# Response to ABP Opinion

In respect of a Residential and Commercial Development at  
Lands located at Scholarstown Road, Dublin 16

Submitted on Behalf of  
Ardstone Homes Limited

November 2019

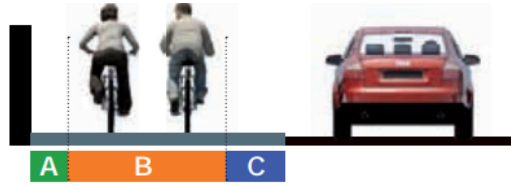
With regard to the type of cycle facility required, the chart below, extracted from the NCM, was referenced. This chart details whether a cycle facility is required to be on a shared street, a cycle lane or a cycle track, and is dependent on the speeds and volume of traffic along the road.

From the traffic surveys undertaken, it was noted that the Annual Average Daily Traffic along the Scholarstown Road is approximately 18,000 No. vehicles. The speed limit along this road is currently 50km/hr. Therefore, the required cycle facility along Scholarstown Road is a cycle track.

A cycle track has been proposed as part of this application on both sides of the Scholarstown Road in the vicinity of the development. These facilities will tie into the existing facilities along the road either side of the development location.

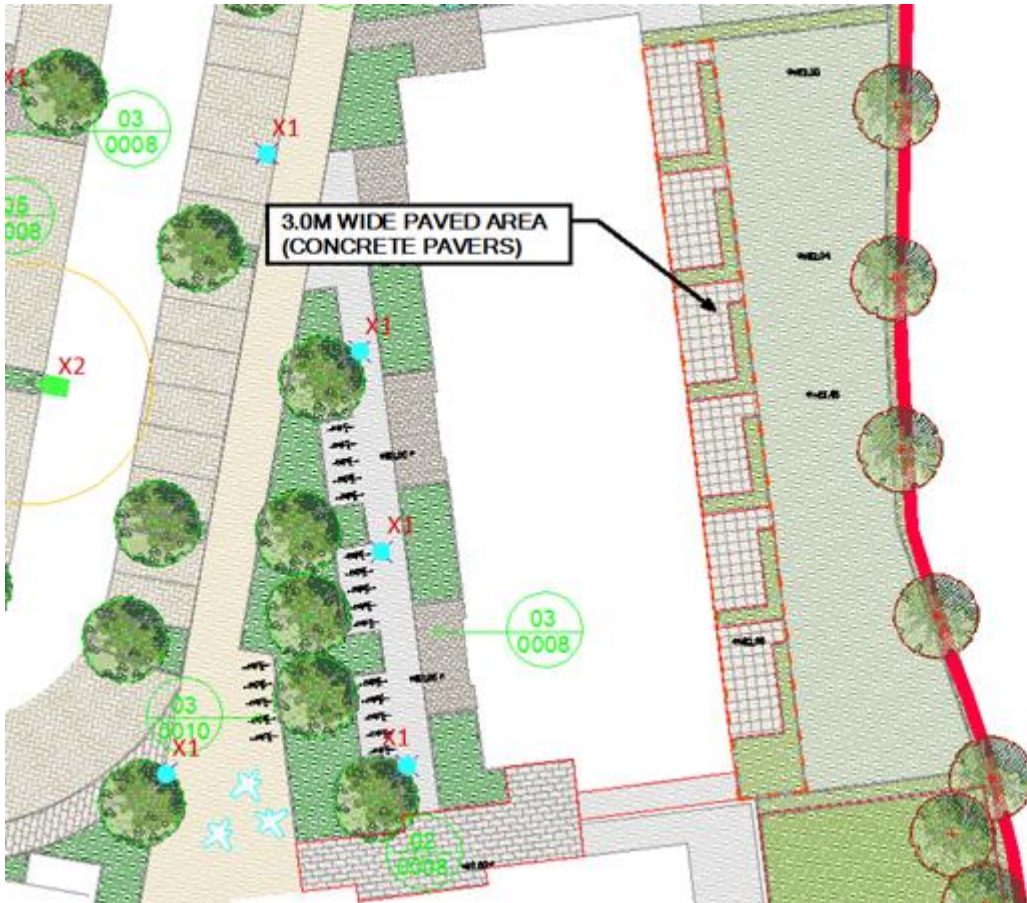
Also attached is a marked up copy of the site drainage plan. As noted on the drawing, the centre line of the 1200 diameter drain generally ranges from 5.0m to 6.0m from the adjacent building line.

A 7.2m wide wayleave is proposed (3.0m either side of the pipe plus the pipe diameter of 1.2m) – indicated by the yellow hatch on the attached drawing. Although it is noted that all buildings are further set back than this minimum. There's also more space between the wayleave and the eastern site boundary.

Just following up on discussions earlier today regarding the wayleave at Ardstone's lands in Scholarstown.

For reference I've also attached the proposed wayleave plan as tabled at yesterday's meeting.
